Plan Commission

Agenda

Monday, September 23, 2019

Request For Plan Commission Action

REVISION DESCRIPTION
							NO.
DATE: SEPTEMBER 9, 2019							
DRAFTED BY: RPH							
CHECKED BY: SRW							
PROJECT NO.: 1660-01-19							
DRAWING NUMBER							
SHEET NUMBER							
C0.1							
						OF 8

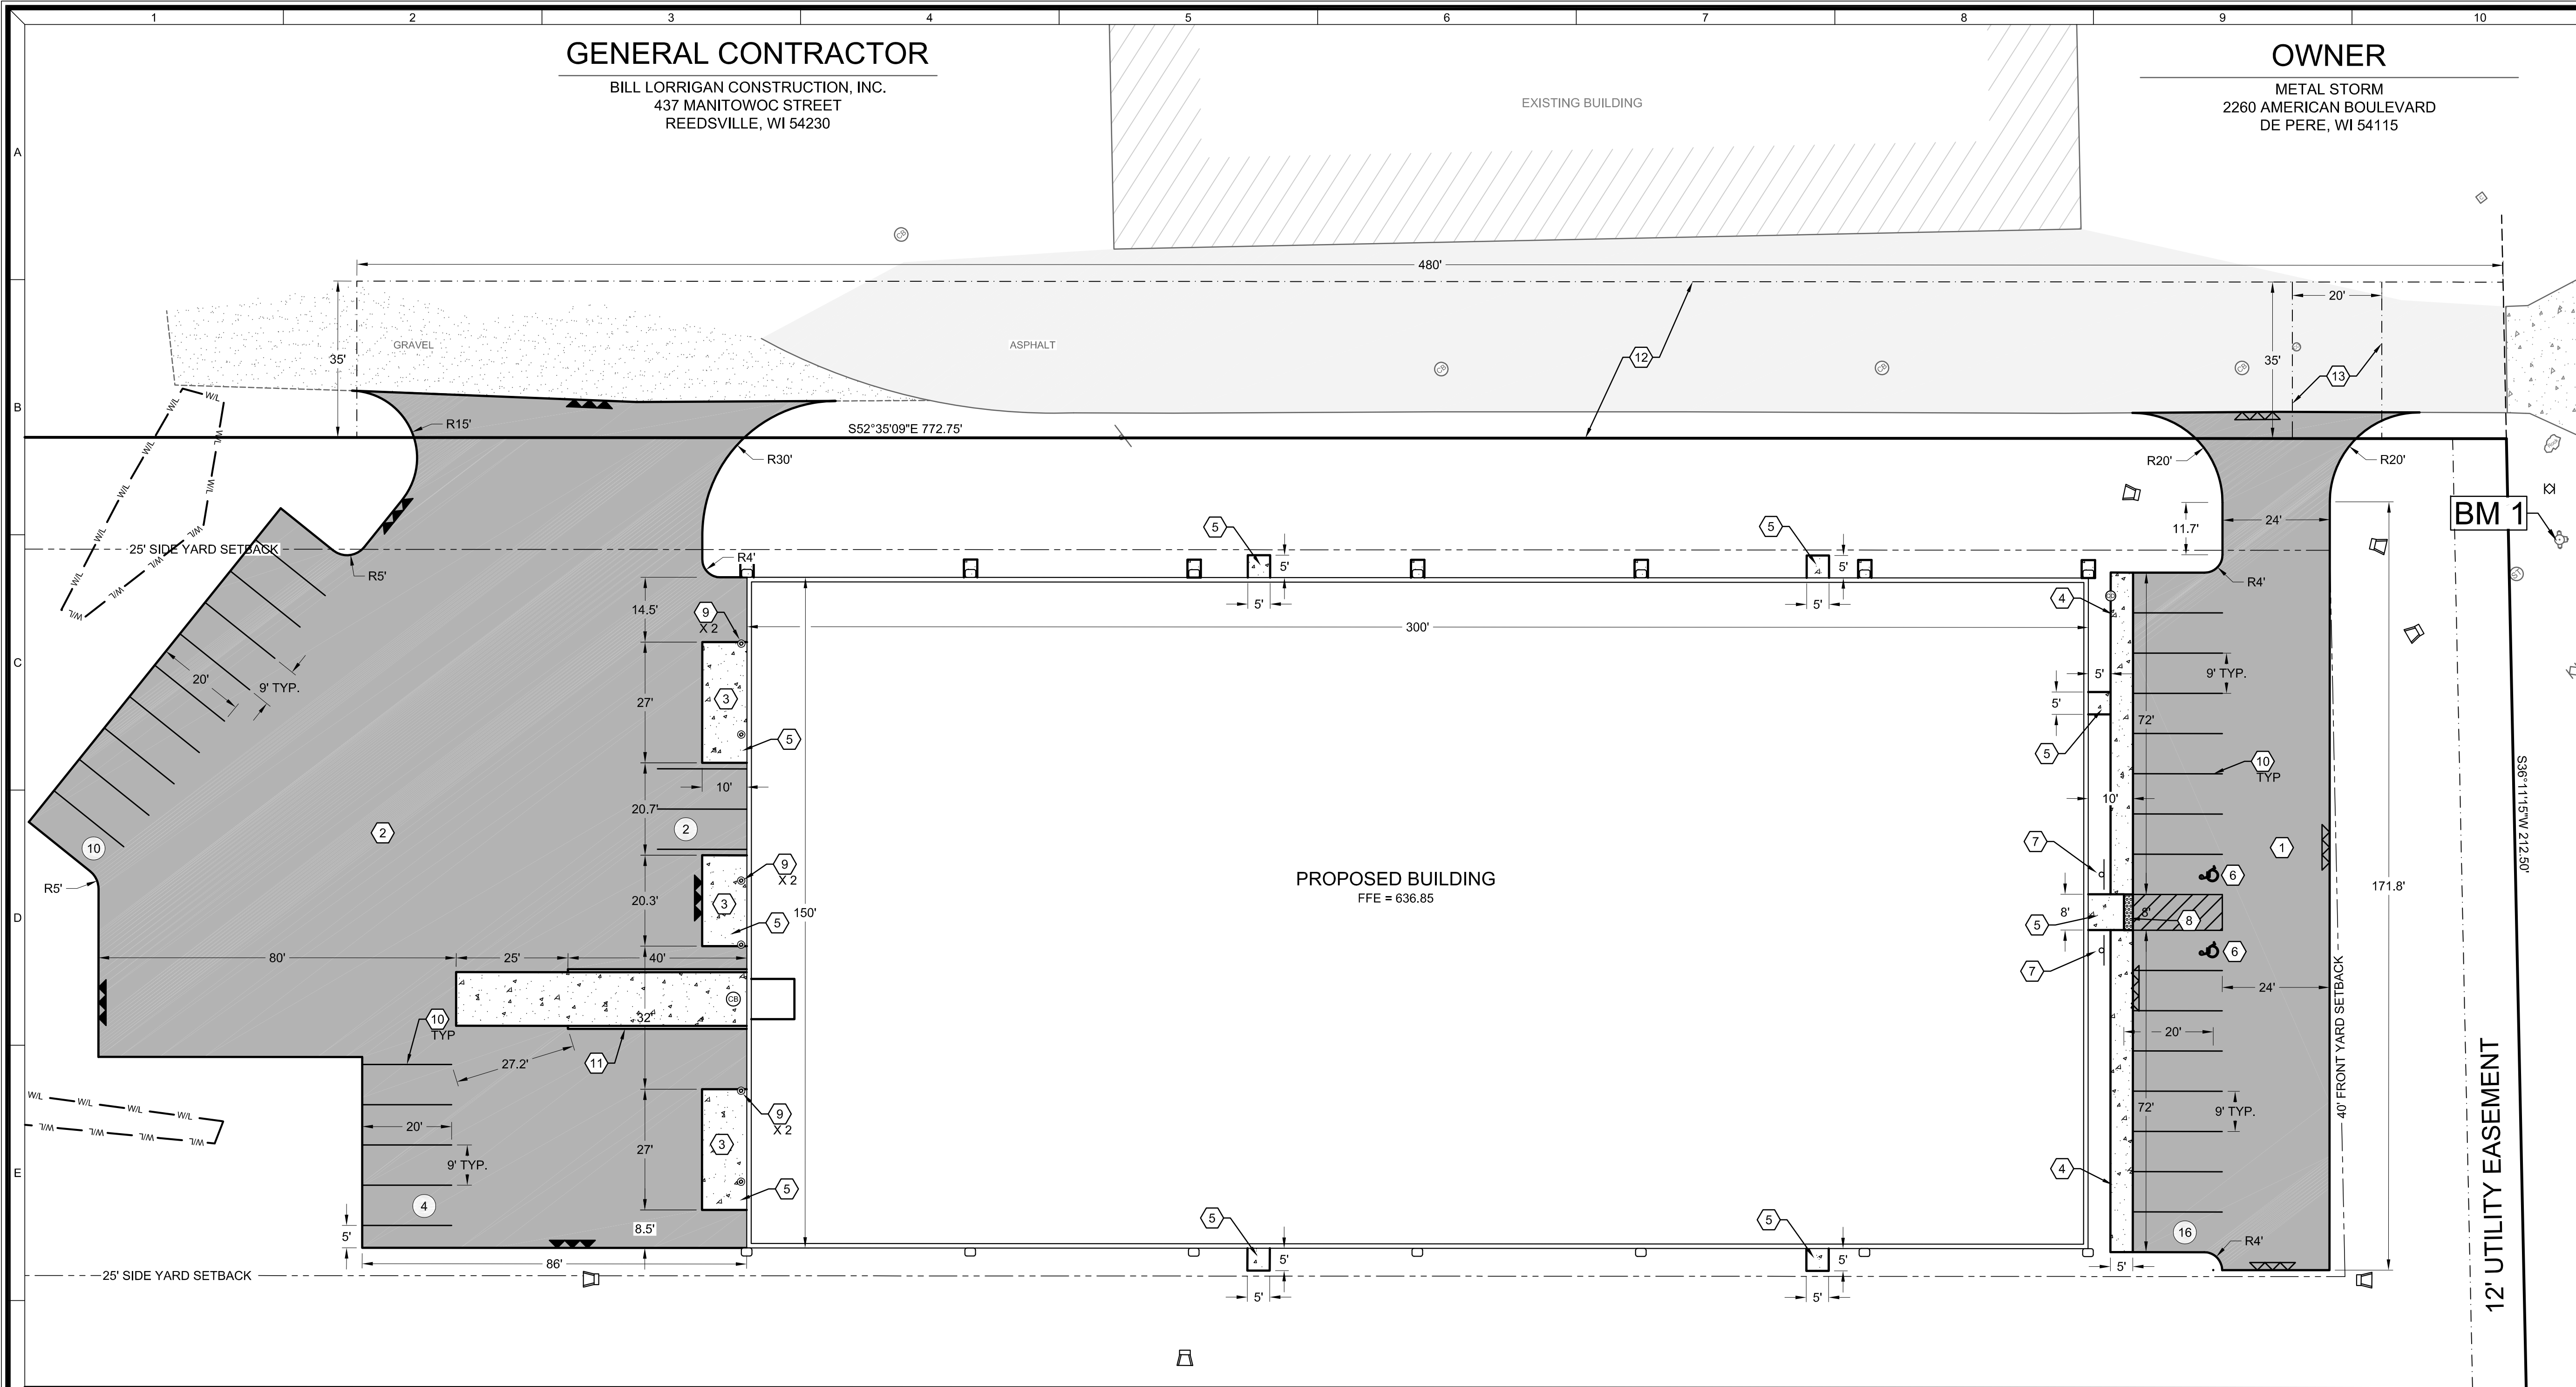
2. Provide soil loss sediment discharge calculations and corresponding map. **USLE calculations and exhibit are included in resubmittal**
3. Sheet C01: List Parcel ID on Cover sheet at the location map. **Added per request**

4. Sheet C01: Provide information if work will be done outside the site, if so "Civil General note #13" is false. It appears that storm sewer shown to be done on property to the south. Also, driveway connections to the property to the north. **Civil General Notes have been revised.**

5. Sheet C01: General Note #15 - Please contact City of De Pere Public Works at least two weeks prior to excavation in right-of-way to obtain permitting. Contact Engineering at 920-339-4061. **Civil General Notes have been revised.**

6. Sheet C.01: Please indicate if concrete work will be done in right-of-way? If there is no work in right-of-way General Note #20 wouldn't apply **Civil General Notes have been revised.**

DATE:	SEPTEMBER 9, 2019
DRAFTED BY:	RPH
CHECKED BY:	SRW
PROJECT NO.:	1660-01-19
DRAWING NUMBER	
SHEET NUMBER	C2.0
OF	8

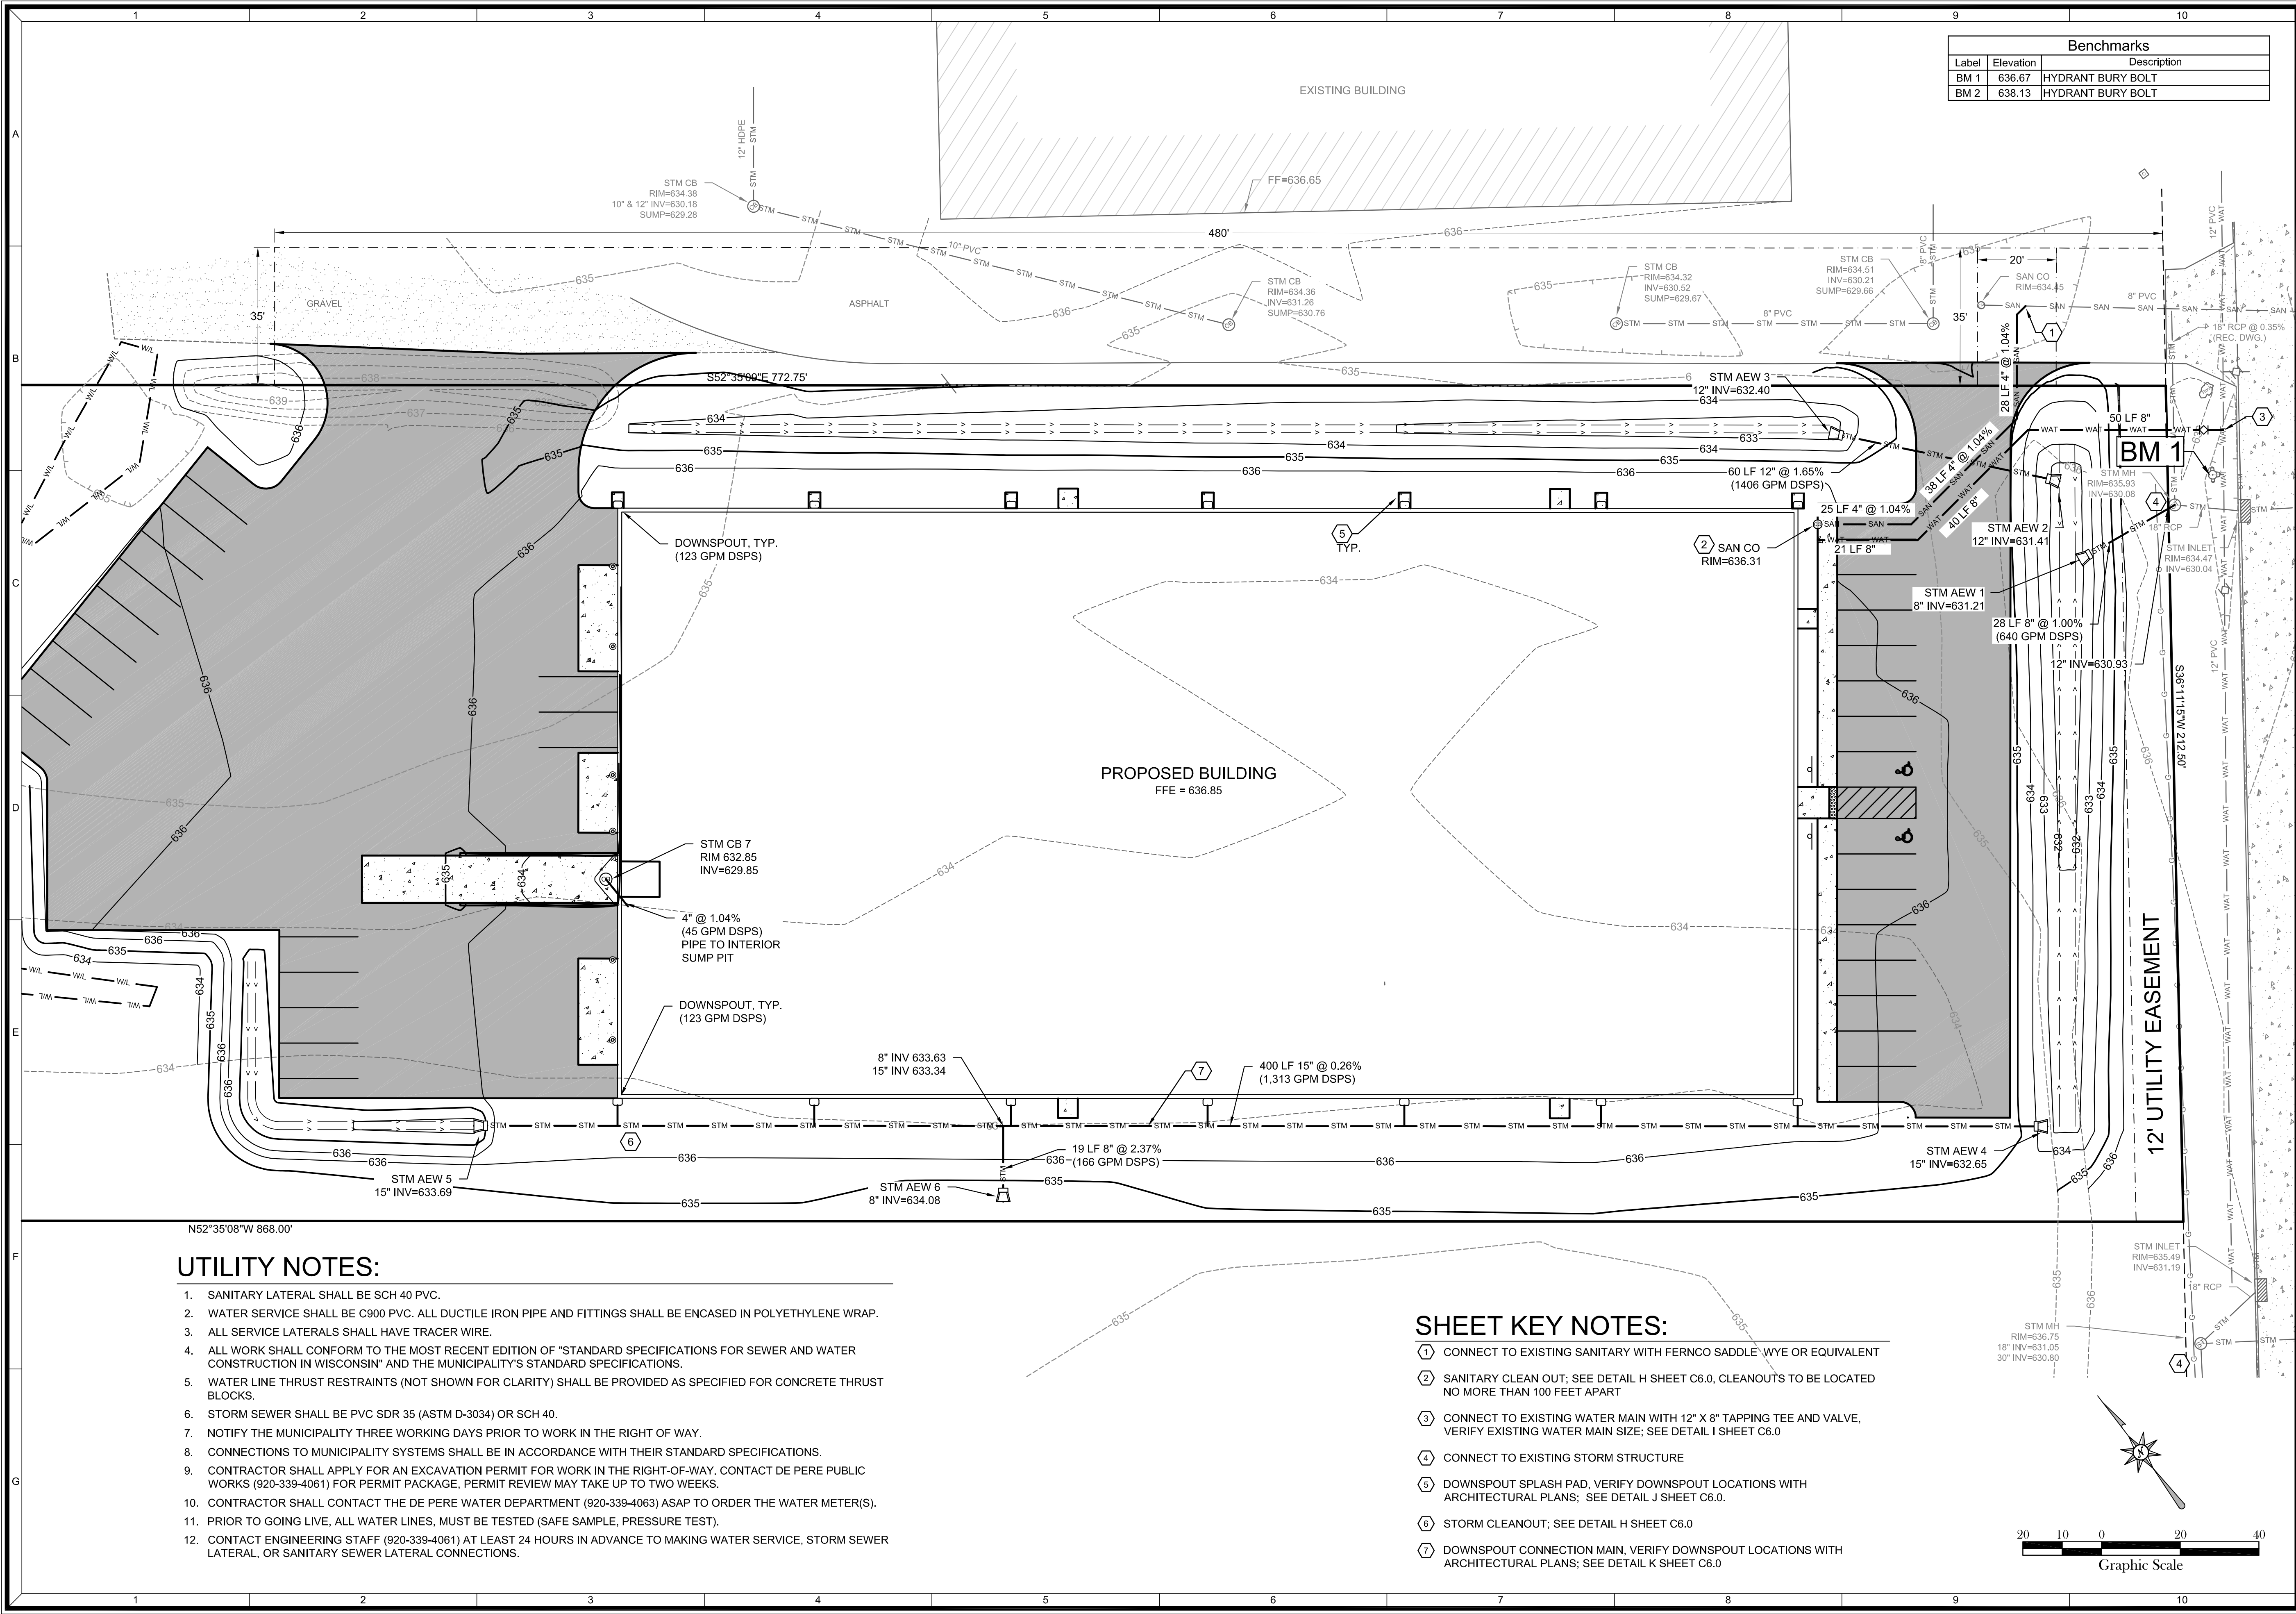
8. Sheet C2.0: Please record an easement or agreement for the shared use of driveways to the north. This comment is resolved if the parcels are being combined. **Both parcel will be under same ownership. Location of access easement has added to plan. Easement to be recorded if required.**

9. Sheet C2.0: Paving would be required at the western most driveway connection to the northern property. Right now, the driveway is connecting to grass. **Driveway is connecting to existing gravel drive.**
